Terex Utilities**PRODUCT NOTICE****PN690****DATE:** 4/14/2021**REVISED:****TO:** Owners, Users, Dealers, and Installers**MODELS AFFECTED:** TL80, TL80/112, TL100**SUBJECT:** Transmission TL Updates**Issue:**

Terex Transmission TL models TL80, TL80/112, and TL100 aerial devices, produced from March 2019 through August 2020, should be upgraded to current production status. There have been several running changes and improvements including: boom tie down, jib transport position, and potential for leaking control valves. **Failure to correct the indicated issues may result in leaking hydraulic fluid at the control valves and damaged components during road travel.**

Figure 3. Elevator pedestal side support not installed, this update applies

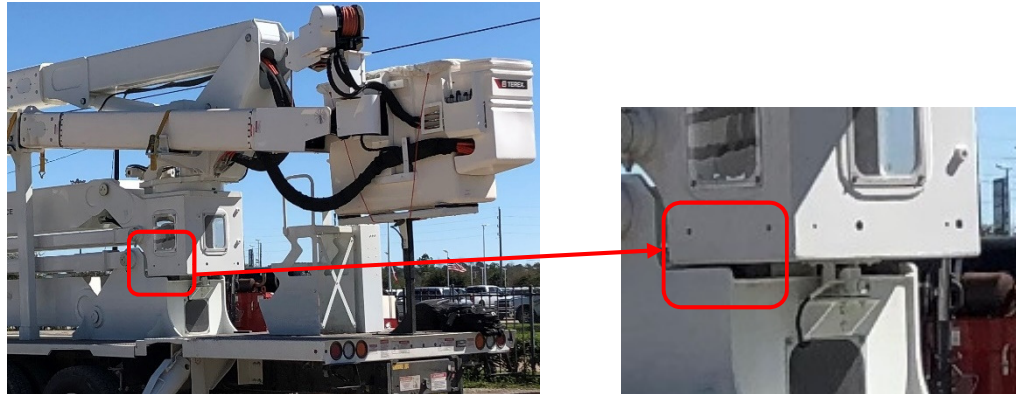
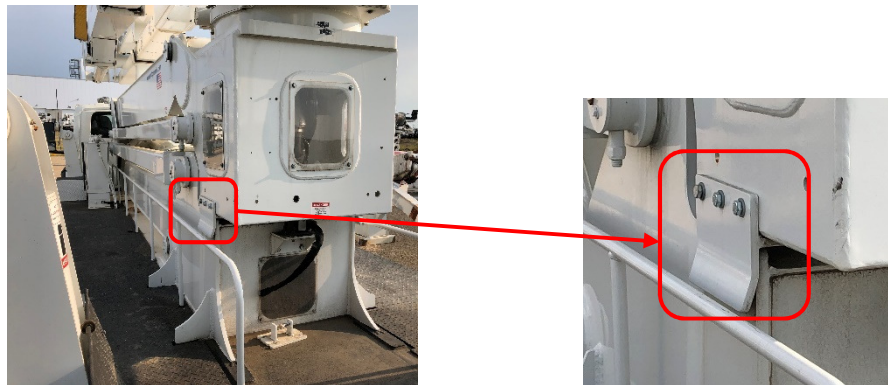
- b. Added elevator pedestal side support (TL80/112 only) – Field Service Kit Z1571
The elevator side supports aid guiding the boom into the latch when stowing the machine when the truck is not level.

Figure 4. Elevator pedestal side support installed, this update may not apply

Figure 5. If the upper wear pads for the lower boom rest are unchamfered, this update applies. If the upper wear pads are chamfered, this update may not apply.

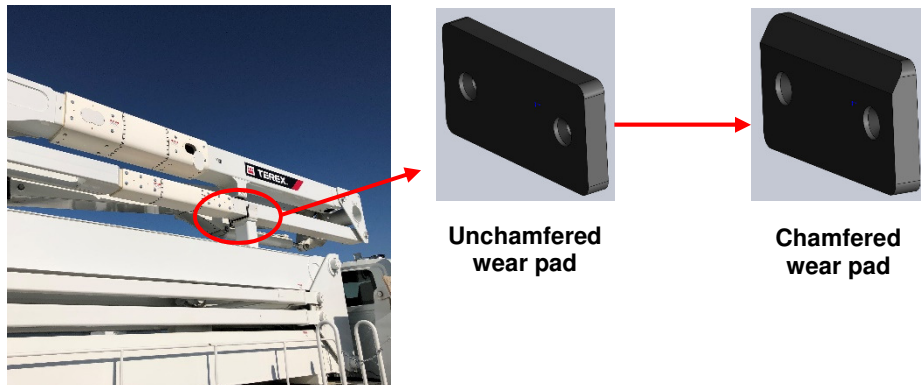
- c. Lower boom rest wear pads with chamfered edge (TL80/112 only) – Field Service Kit Z1586
Unchamfered wear pads can be damaged when lower boom is stored if the lower boom is not aligned with the rest. The chamfered pads help guide the lower boom into position.

Figure 6. If the compensator link lower bolts are hex head, this update applies

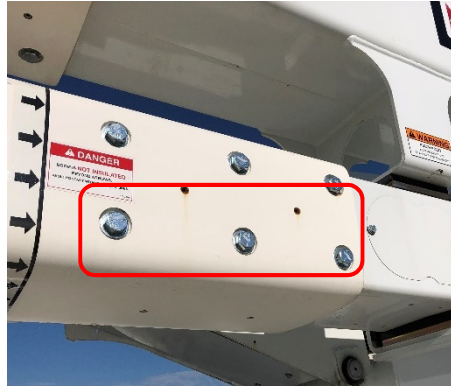
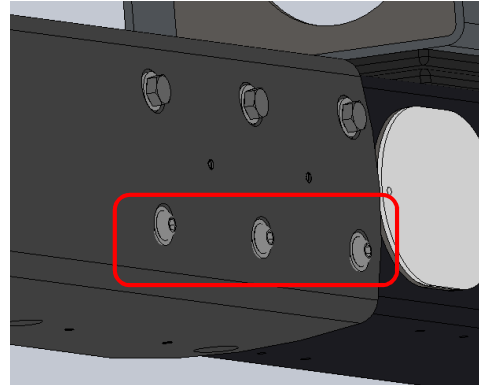
- d. Bolts for compensation link changed from hex head to button head (TL80 & TL100 only)
– Field Service Kit Z1596
If the location of the lower boom rest falls in the highlighted area, the bolts should be changed to button head bolts as the hex head bolts can damage the wear pad. This only applies to the TL80 and TL100; it does not apply to the TL80/112 units with a hydraulic lift.

Figure 7. If the compensator link lower bolts are button head, this update may not apply

Figure 8. Basket rest reinforcement installed, this update may not apply

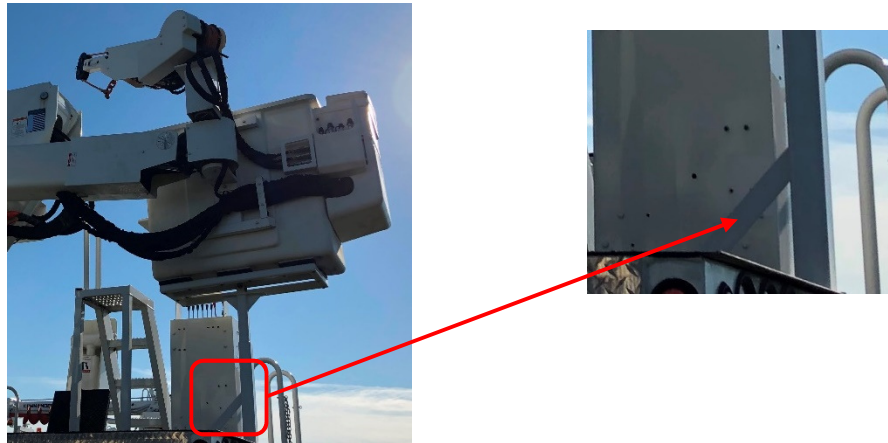
- e. Basket rest reinforcement – Field Service Kit Z1571 (TL80/112) or Field Service Kit Z1573 (TL80 & TL100)

A reinforcement is added to the basket rest support to stiffen the support tube.

Figure 10. Upper control valve extra return line and vent added, this update may not apply

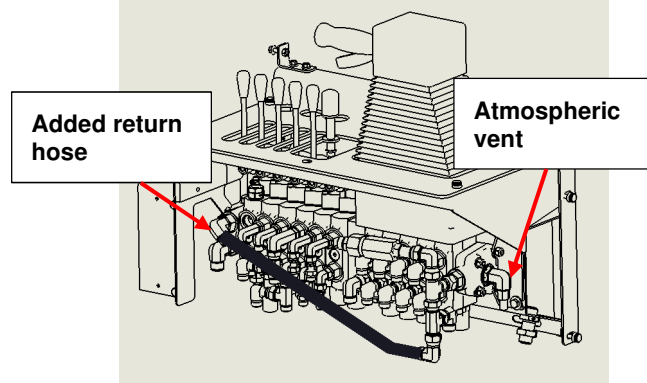
- a. Hydraulic leaks from the upper and lower control valves
- b. Additional return line and atmospheric vent at upper control valve (TL80, TL80/112, TL100) – Field Service Kit Z1583

In order to reduce backpressure and potential related hydraulic leaks, an additional return line and atmospheric vent is added to the upper control valve.

Figure 9. Upper control valve extra return line and vent not added, this update applies

Figure 11. TL80/112 Control Valve. If the hose shown is present, this update may not apply

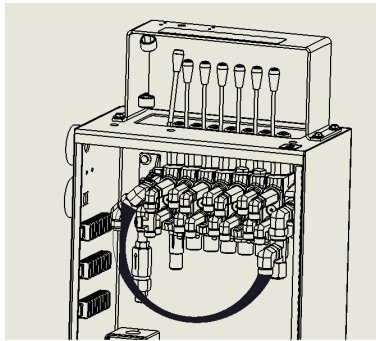
- c. Additional return line at the lower control valve (TL80, TL80/112, TL100) – Field Service Kit Z1583

In order to reduce backpressure and potential related hydraulic leaks, an additional return line is added to the lower control valve.

Figure 14. Jib can store over rear corner of platform, this update applies

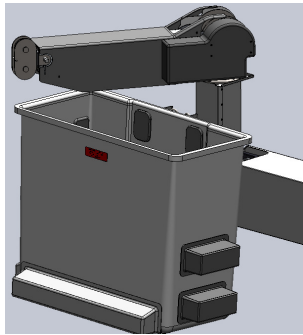
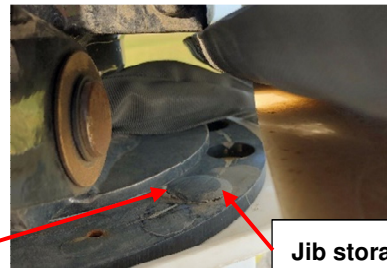
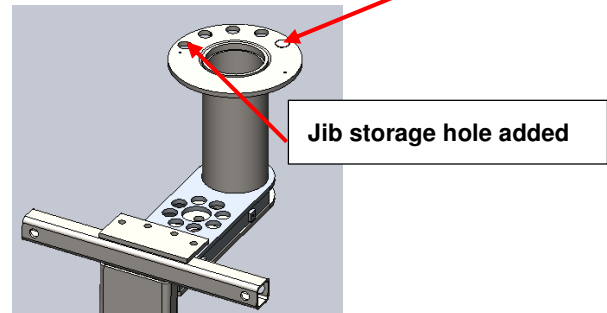
- a. Jib storage change makes it easier to access the controls– Field Service Kit Z1571 (TL80/112) or Field Service Kit Z1573 (TL80 & TL100)

The rearmost jib storage position is plugged as it does not allow easy control access in that position. An additional jib storage position is added to allow the jib to store more in-line with the upper boom, allowing for easier control access and platform entry.

Figure 15. Jib storage limited to eliminate over rear position, this update may not apply

Figure 16. If the metal support shown is present, this update may not apply

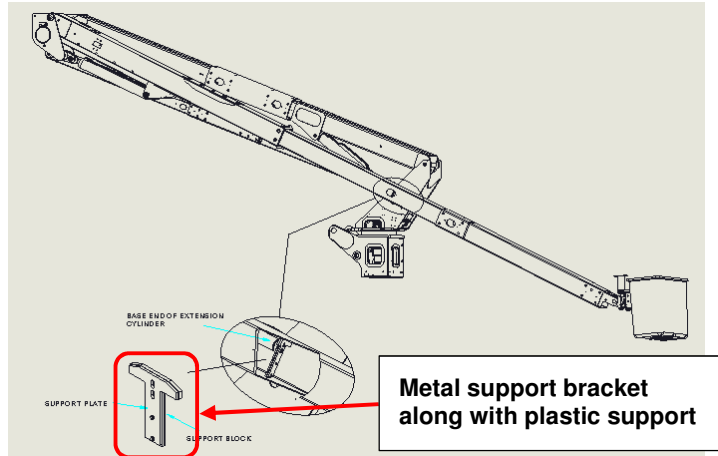
- a. Addition of metal support bracket for the end of the extension cylinder (TL80, TL80/112, TL100) – Field Service Kit Z1606
A metal support is added to aid in properly supporting the cylinder.
